U.S. Department  
of Transportation  
**Research and  
Special Programs  
Administration**

Ref. No.: 02-0330

**Subject: Shear Sections on Aggreko IM-102 Vessels**

**Subject: Internal Discharge Valves on Aggreko IM-102 Vessels**

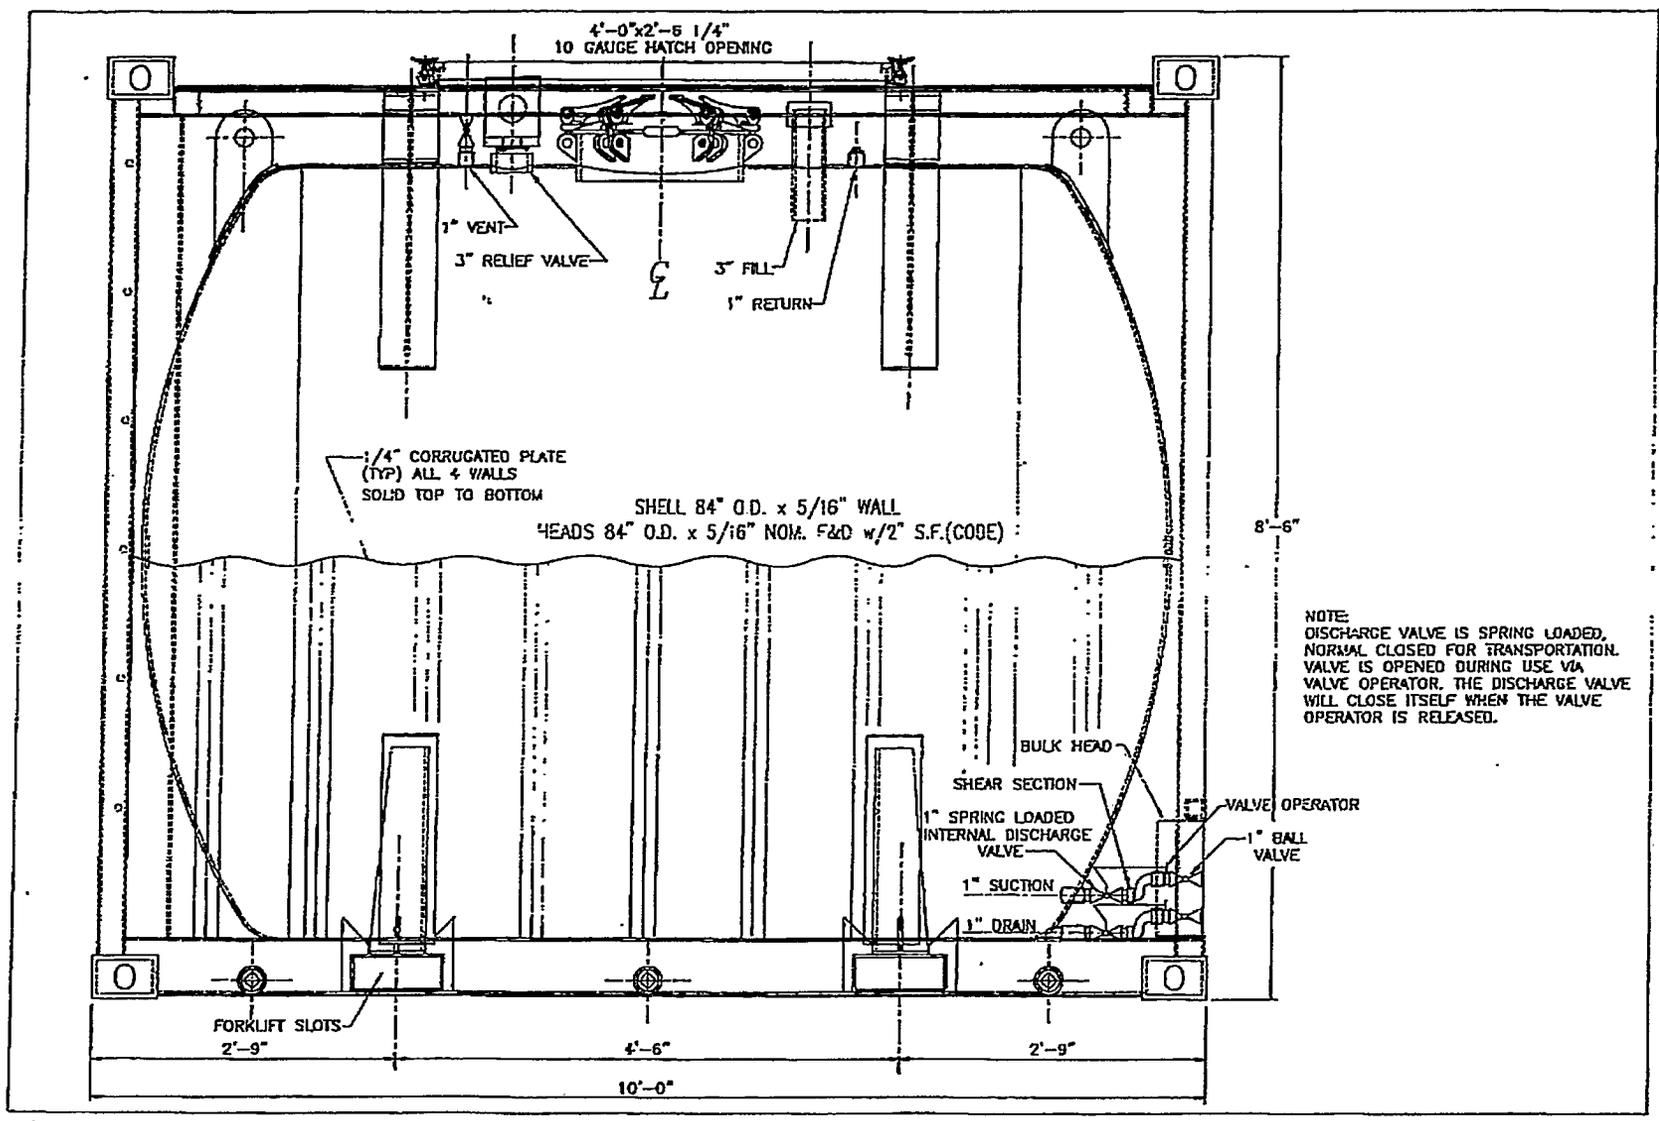
For our 2,300 Gallon IM-102 Vessels (See Attached Sketch), if we locate internal discharge valves within the secondary containment container which completely encloses the tank with 1/4" corrugated plate, the internal discharge valves will be fully protected from all external forces and thereby would meet the intent of 178.270-12(c).

Please advise as to whether or not this does in fact meet the intent and is thereby an acceptable design.

You describe an internal discharge valve which is located on the exterior of a 2,300 gallon IM 102 steel portable tank. The tank is completely enclosed with 1/4" corrugated plate (diagram enclosed), which protects the internal discharge valve from all external forces. You asked if this arrangement meets the requirements in § 178.270-12(c).

The answer is no. For an IM 102 steel portable tank, each internal discharge valve must be self-closing, located inside (on the interior) the tank, within the welded flange or within its companion flange. An internal discharge valve which is located outside the tank, even though it is within a 1/4" corrugated plate which completely surrounds the tank, does not meet the requirements in § 178.270-12(c).

SKETCH 1  
PLAN VIEW  
TYPICAL FLANGE NOZZLE  
SCALE: NTS

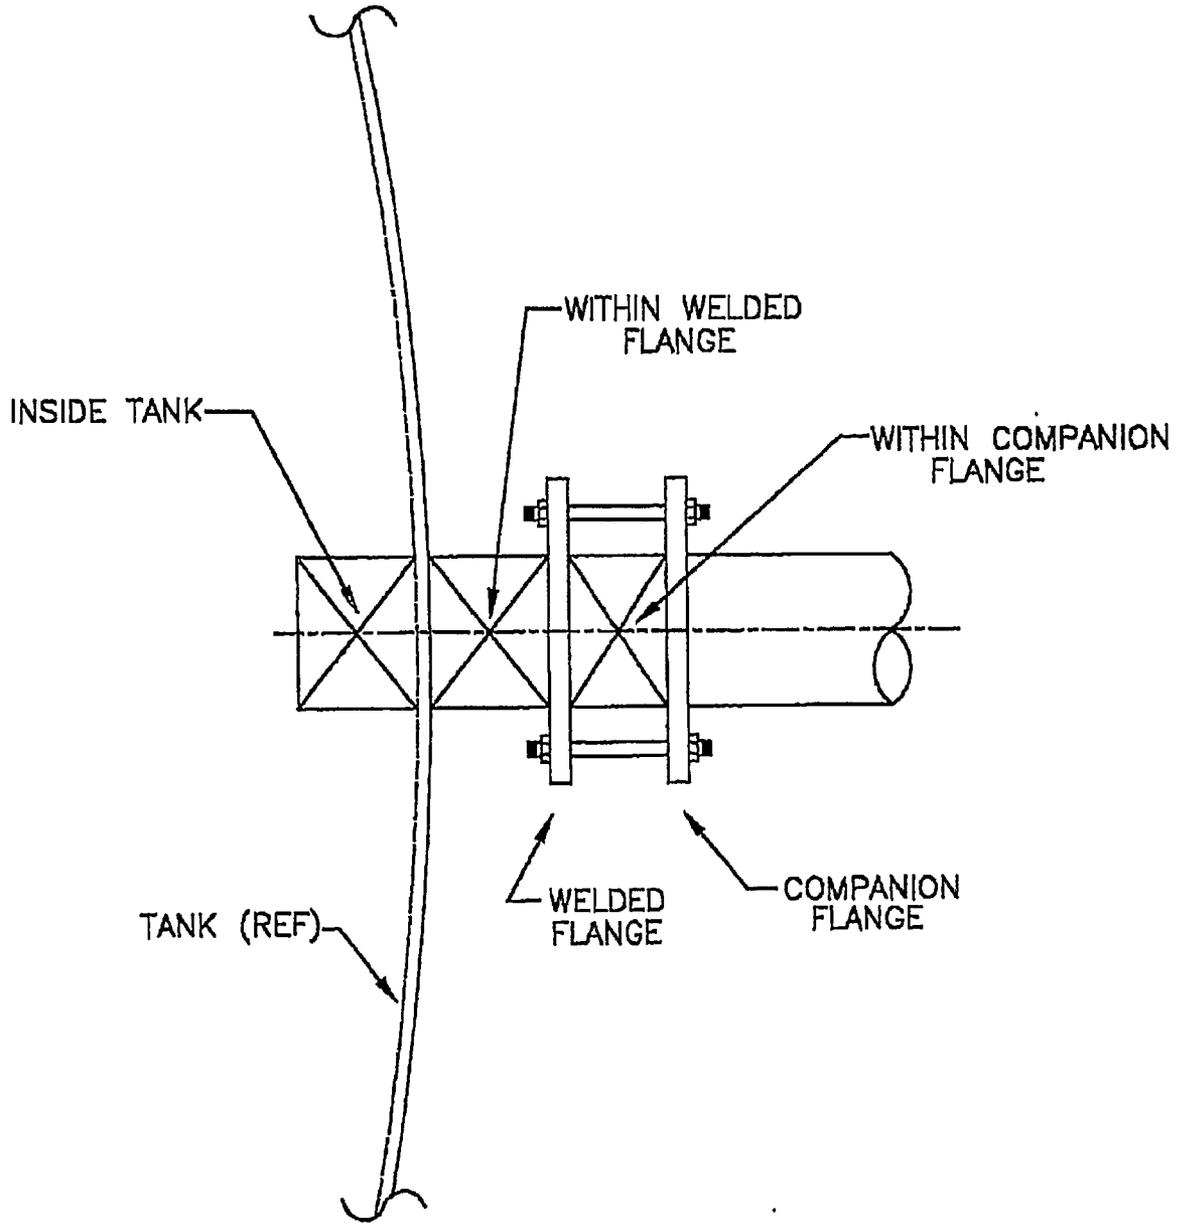
The attached sketches show our proposed internal discharge valve installation on the IM-102 vessels we are manufacturing. Per 178.270-12(c), an internal discharge valve must be located inside the tank, within the welded flange or within its companion flange (See Sketch 1). Since these tanks have threaded fittings instead of flanged nozzles, allowable by both ASME Section VIII, Div. 1 and IM-101/102, the term flange does not apply and must therefore be replaced with fitting. With this, the 1" 90° Ell is the "welded flange" and the 1" shear section is the "companion flange" (See Sketches 2 and 3).

SKETCH 2  
PLAN VIEW  
1" DRAIN  
SCALE: NTS

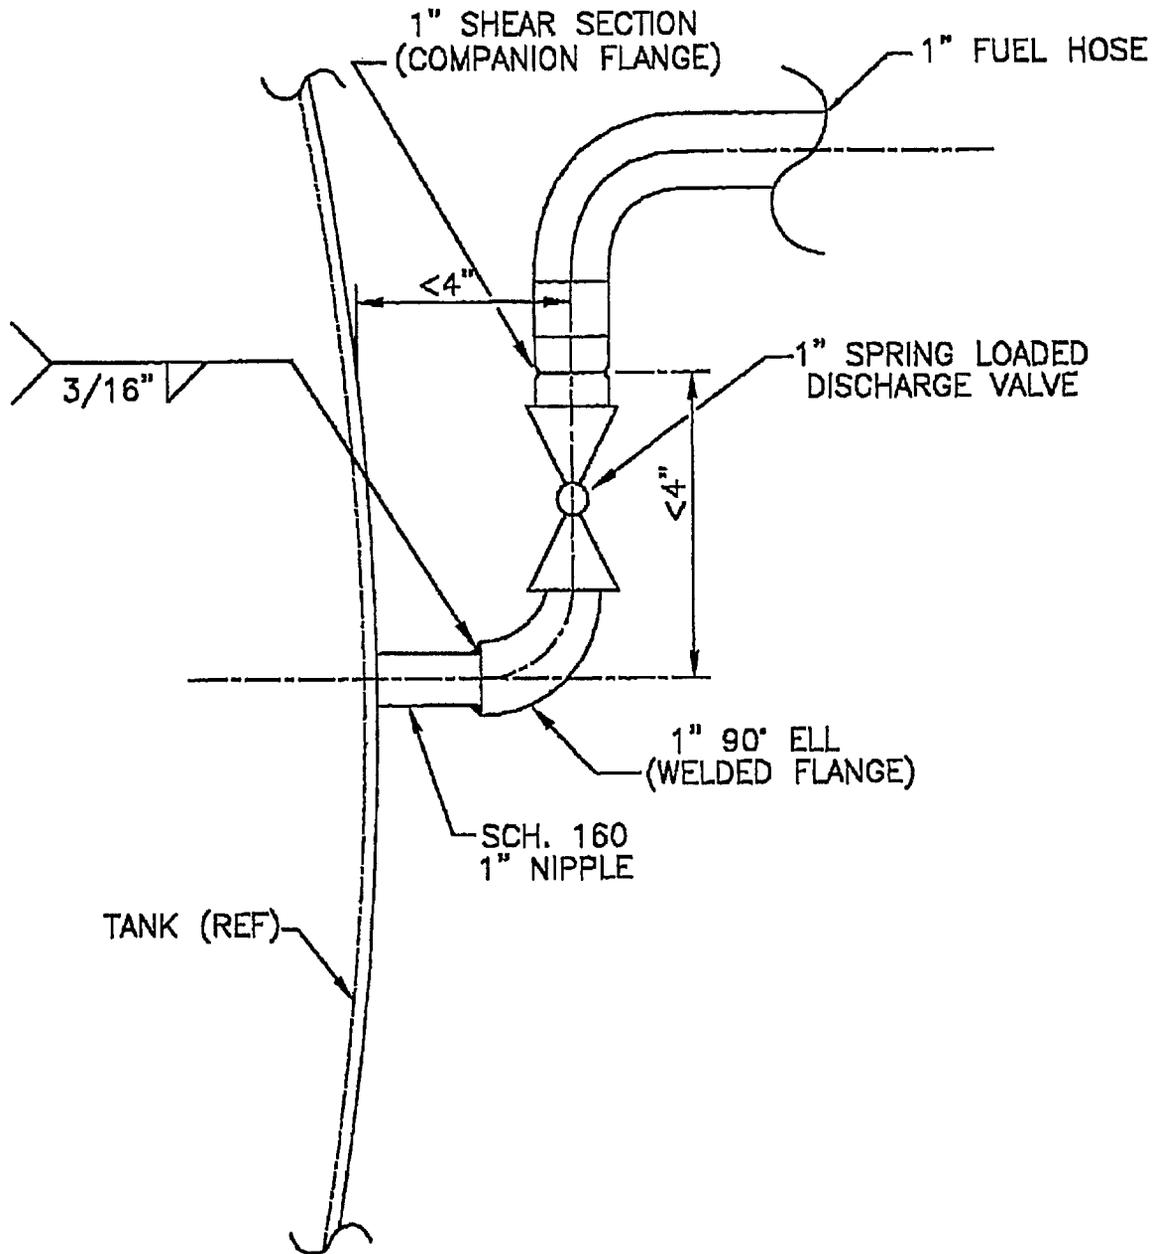
The shear section is located outboard of the internal discharge valve seat and within 4" of the vessel as required by 178.270-12(d) (See Sketches 2 and 3).

There is insufficient information whether the shear section is located within 10.2 cm (4 inches) of the tank vessel, as required by 49 C.F.R. § 178.270-12(d), when measured along the length of the discharge piping. We do not agree that the 4" requirement can be read to refer to empty space between the outside of the tank vessel and the discharge piping as shown in the sketches provided with your September 18 letter.

The location of the shear section on the IM 102 portable tank must be measured along the length of the discharge piping because the shell or head of the tank is best protected from the transfer of excessive moments when the entire shear section is within 4 inches of the shell or head, rather than when just the nearest point of the shear section is within that distance of the shell or head.
